Variance Request Form

Variance: 033
Request No.: Rev 0
Date Submit: 10/19/2012
Date Approval Needed: 10/24/2012
Date Agency Received: _____
Agency Approval Reference No.: _____

OCOTILLO WIND PROJECT: IMPERIAL COUNTY, CALIFORNIA

VARIANCE 33 - OCTOBER 19, 2012

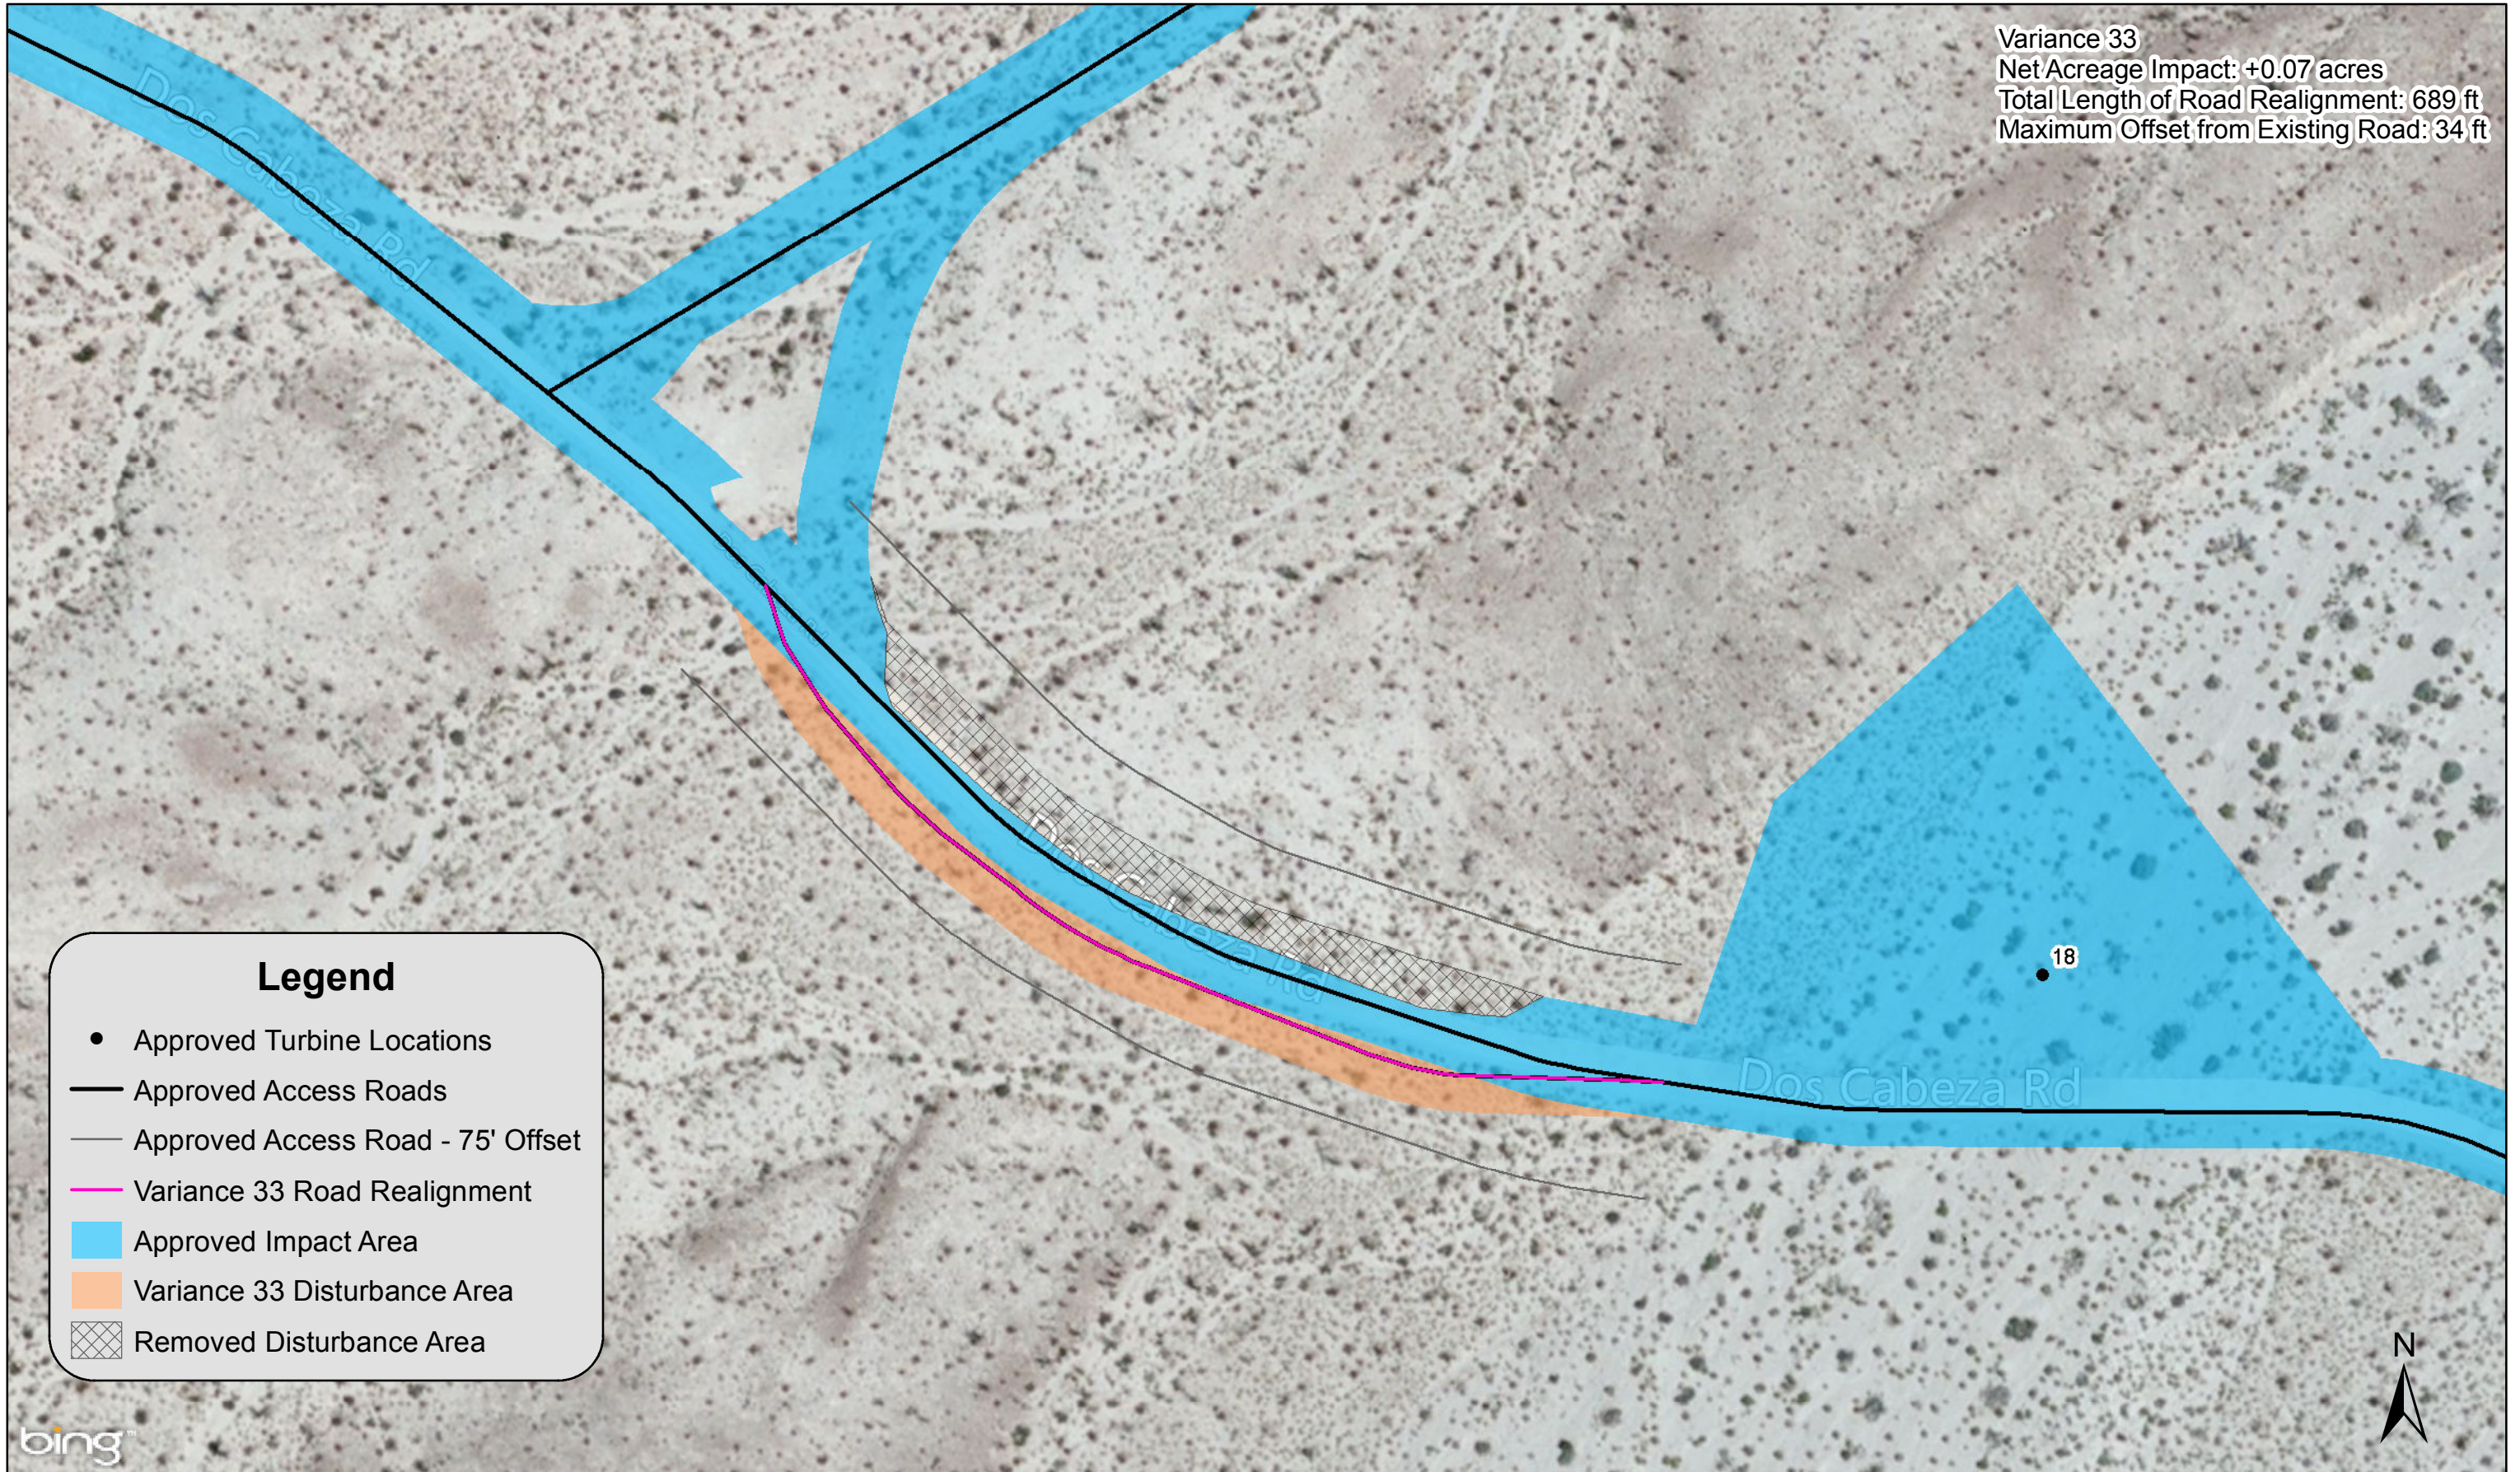
Variance 033 includes modifications to the access road and collection circuit corridor along Dos Cabezas Road between Turbines 16 and 18 (see map attachment). The total length of the access road and collection circuit corridor realignment along Dos Cabezas Road is 689 feet with a maximum offset of 34 feet from the currently approved access road and collection circuit corridor alignment.

Variance 33
Net Acreage Impact: +0.07 acres
Total Length of Road Realignment: 689 ft
Maximum Offset from Existing Road: 34 ft
